# Penrith Lakes

## Response to submissions received against DA2 Modification 12 and DA3 Modification 10

December 2025

Figure 3-1 Heat map showing the relative increase in material import under the modification applications

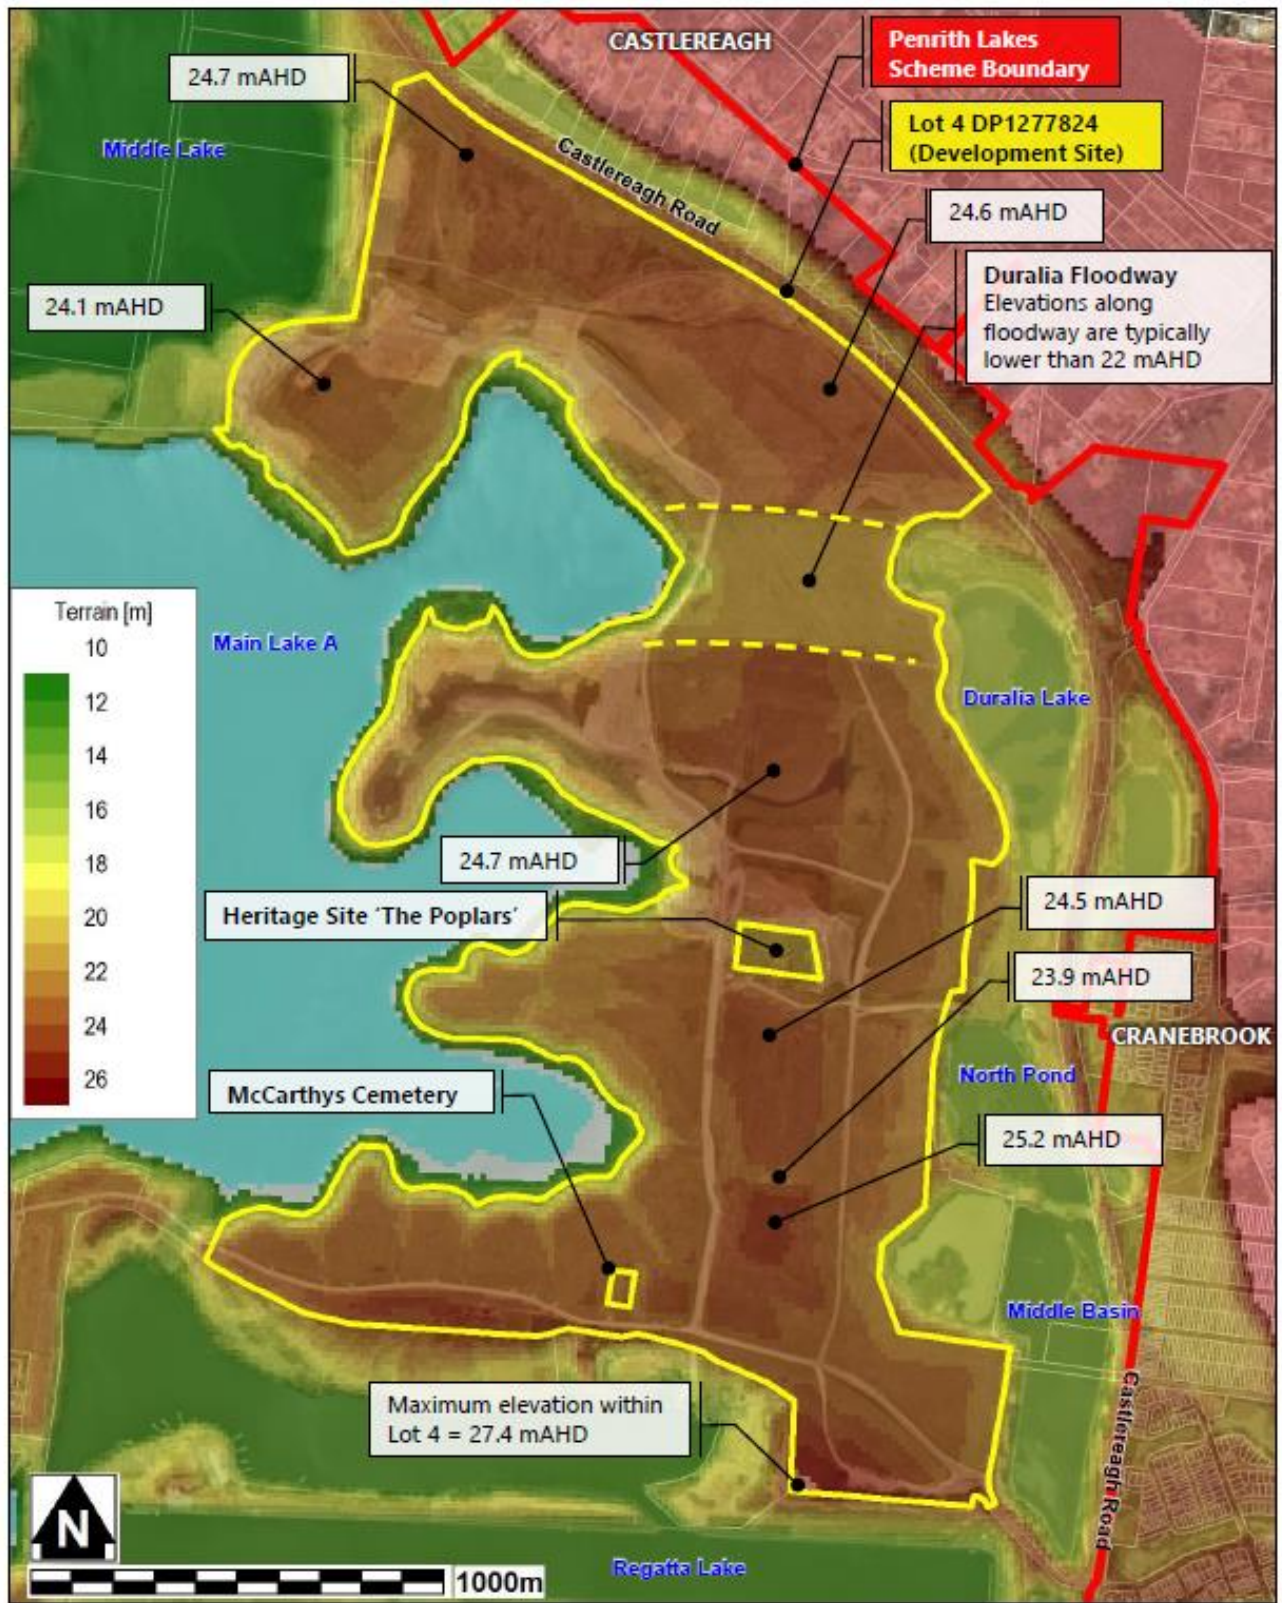
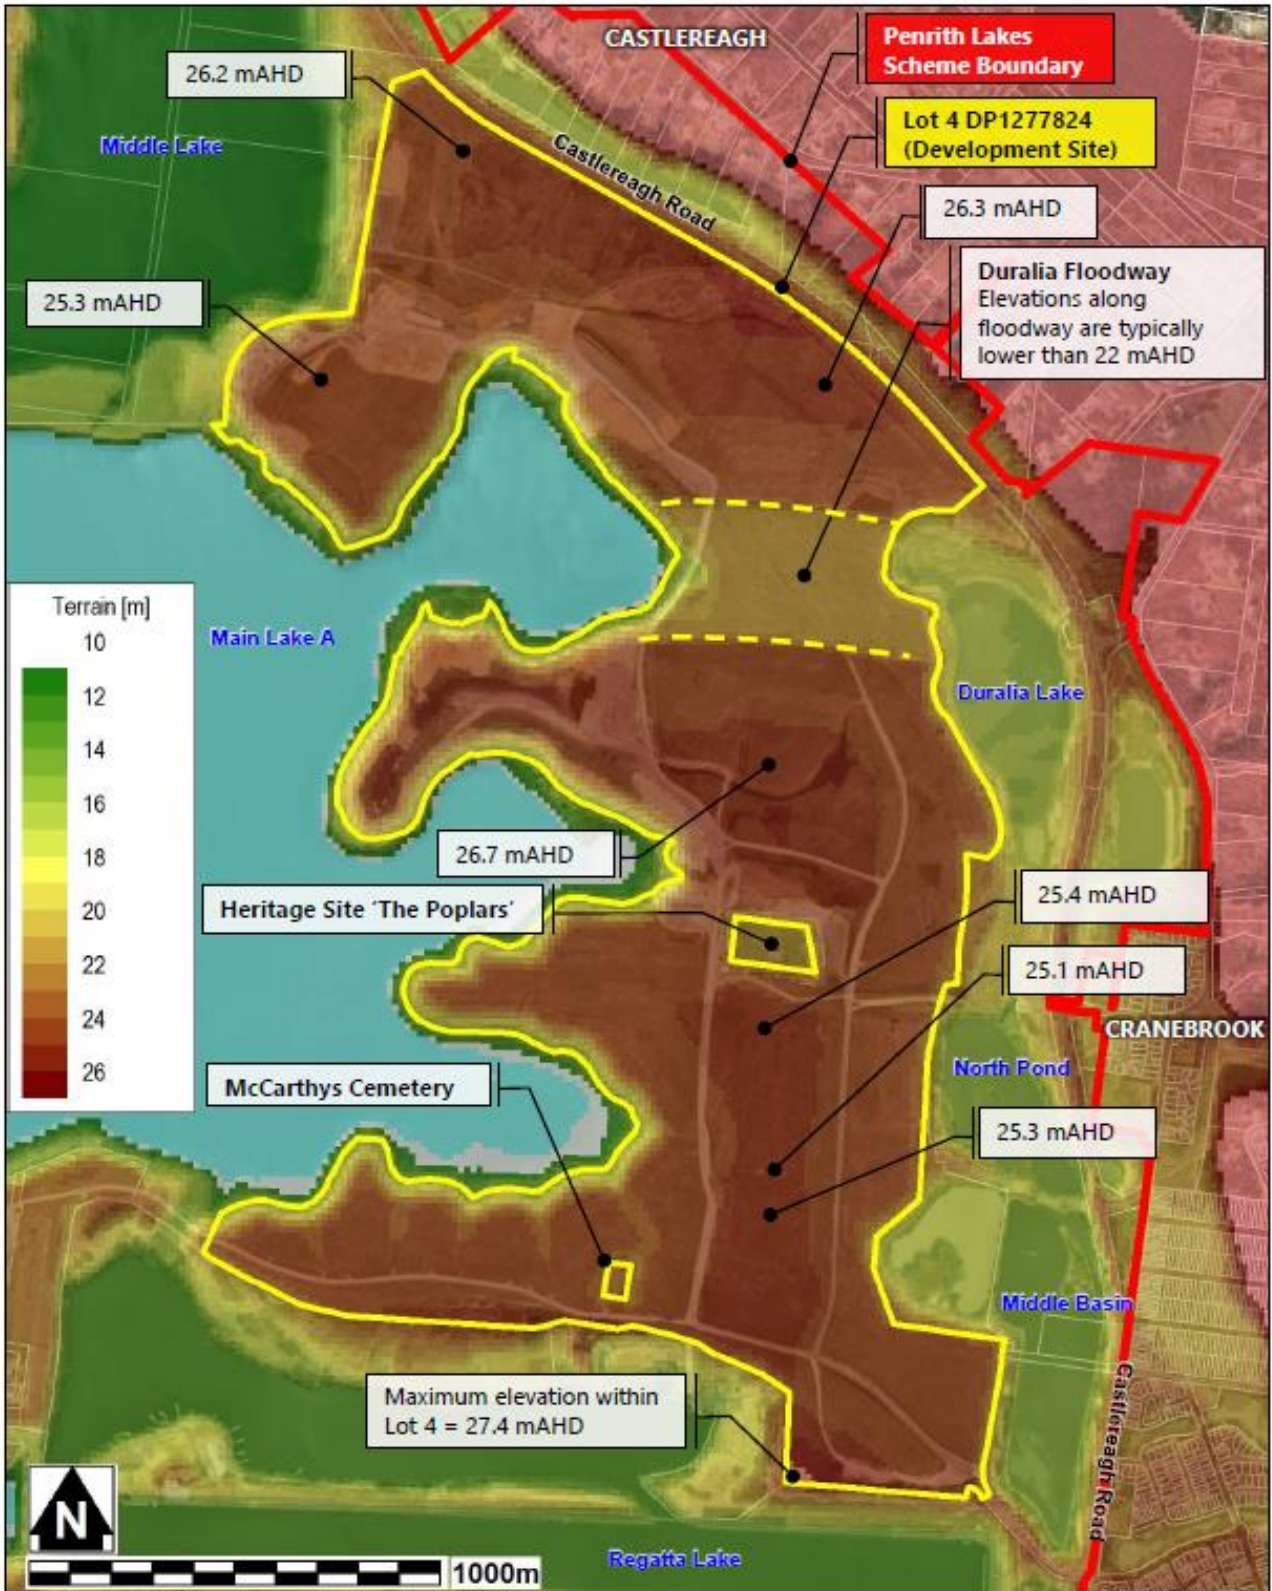
The original proposal involved importing 9.7 million tonnes of material. While the 2024 design met the intent of the existing approval, the updated modelling identified opportunities to further reduce potential changes to predicted flood levels, particularly in larger, rarer flood events. In response, PLDC has amended the bulk earthworks strategy to create a more flood-efficient landform, with a focus on reducing the quantity of fill while maintaining the desired ground level outcomes across Lot 4.

A comparison of existing ground levels and the revised proposed levels (refer Figures 3-1 and 3-2) shows a pattern of moderate increases across the site, with the amount of change varying in accordance with the natural topography:

A key revision involved reducing the depth of fill across the northern half of Lot 4, where earlier modelling indicated potential for more noticeable effects on flood levels and flow paths. The revised design applies shallower fill across the portion of the site on the northern side of the Duralia Lake to Main Lake floodway, adjusts platform gradients to improve transitions, and refines tie-in points to avoid unnecessary redirection of floodwaters. Together, these refinements reduce the overall importation requirement to around 6.8 million tonnes, providing a clearer and more efficient design outcome.
